SUBJECT: NLS-85/03
Technical Specification Figure 6.2.1-1 page 6-3

FIGURE 6.2.1-1 OFFSITE ORGANIZATION

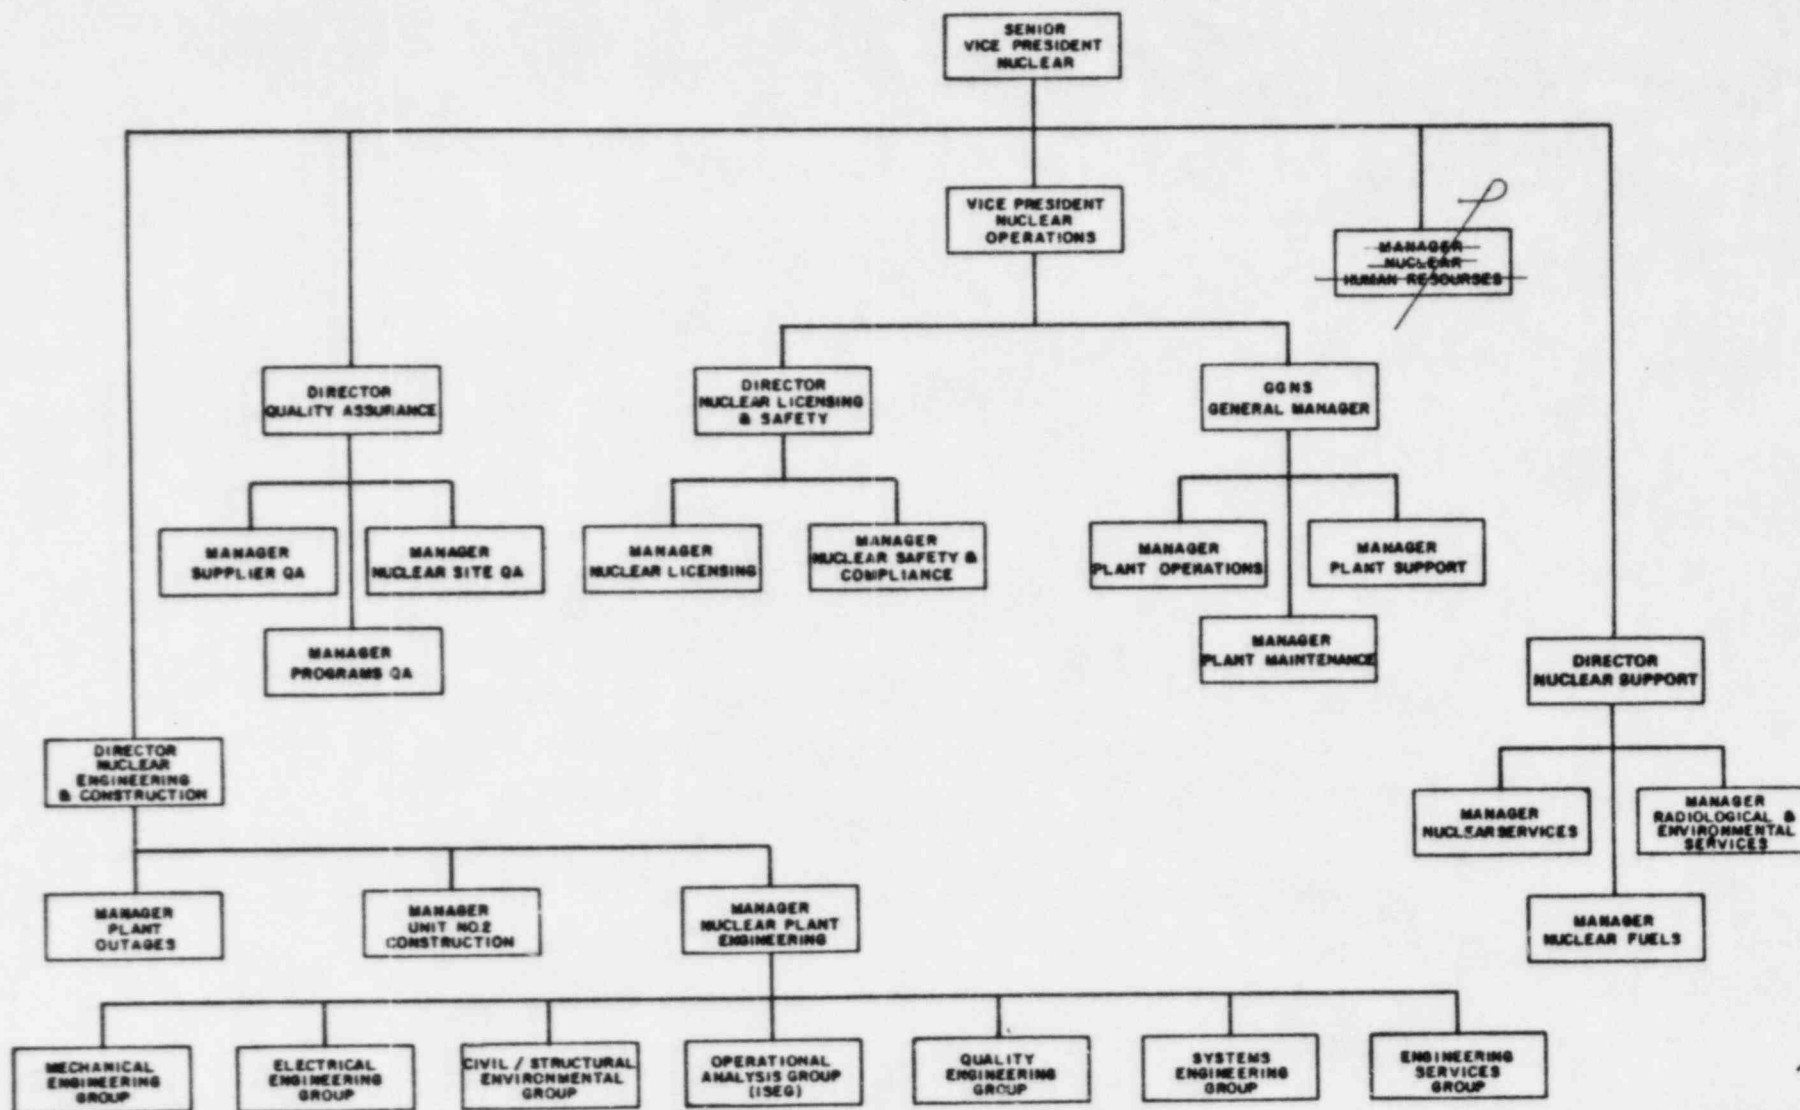
It is proposed that the Manager, Nuclear Human Resources' responsibilities be incorporated under the Manager of Employment position and that the title change be duly noted, thereby removing the position from the subject specification figure.
